Model Series 463 AMG: Active Distance Assist and Active Brake Assist IC Message and DTC U0416FE

Topic number	LI54.71-P-078112
Version	3
Function group	54.71 - Camera and radar-assisted assistance systems
Date	6/17/25
Validity	463 AMG
Reason for change	Updating remedy

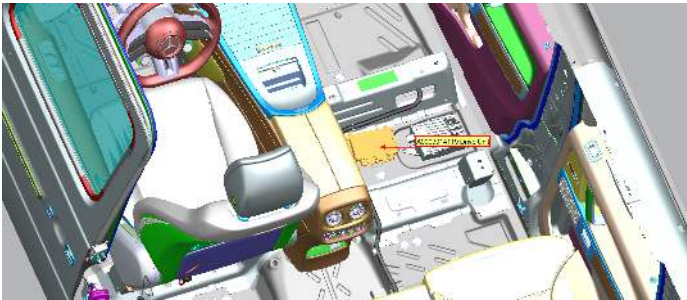
Missing wire between Drive Unit (N145) and Supercap (C8).

Professionally create a new connection by:

- Using a red/white cable with cross-section 0.35 mm² and overall length of approximately 2m.
- Connect Drive Unit (N145) plug A pin 18 to the 3-pin plug of the Supercap (C8) terminal 15 pin 2. Reference the new wire routing location as shown by the red line in "Picture 1 - Connection from Supercap to Drive Unit".
- The new wire should be added to the existing wiring harness as shown by the red line "Picture 1 - Connection from Supercap to Drive Unit".
- Z-Splice is the preferred method using A 000 982 91 10.
- Crimp Contact Pin (MLK) for the Drive Unit (N145) is A0485450328.
